# MEMORANDUM

| <b>Service</b>              | WBC Ecology                                                                                                                              | <b>App No:</b> | 251421 |
| <b>Address:</b>             | N/A, Land At Old Forest Road, Wokingham.                                                                                                 |                |        |
| <b>Proposal:</b>            | Full application for erection of 53 no. dwellings with associated landscaping, parking, drainage, open space and other associated works. |                |        |

Our available aerial imagery from 2022 (flown and captured on 20 April 2022) shows worn areas from paths across the two fields:

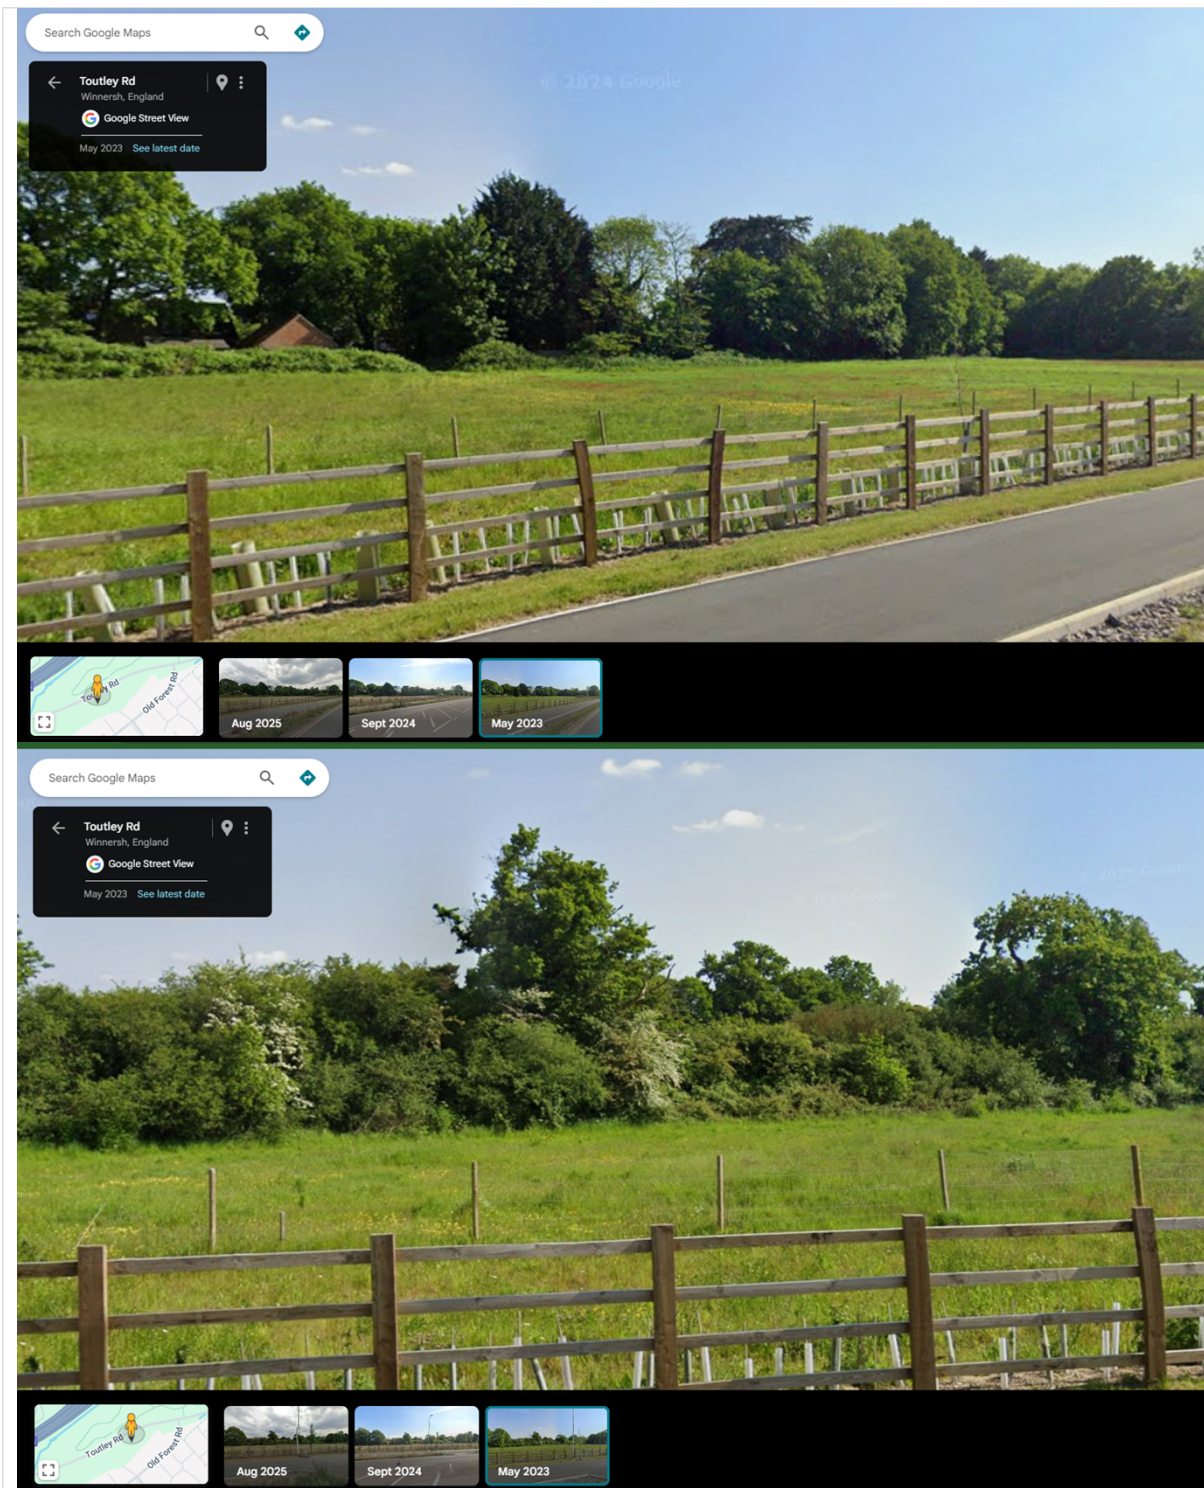
In the meantime, I shall provide some annotated screenshots to support my view that this site has met the sward height condition criterion in the period since January 2020 and that the mowing which has reduced the condition assessment value at the time of the EclA assessments should be considered degradation.

I therefore think it reasonable to conclude that the baseline condition of the grass fields is recorded as good.
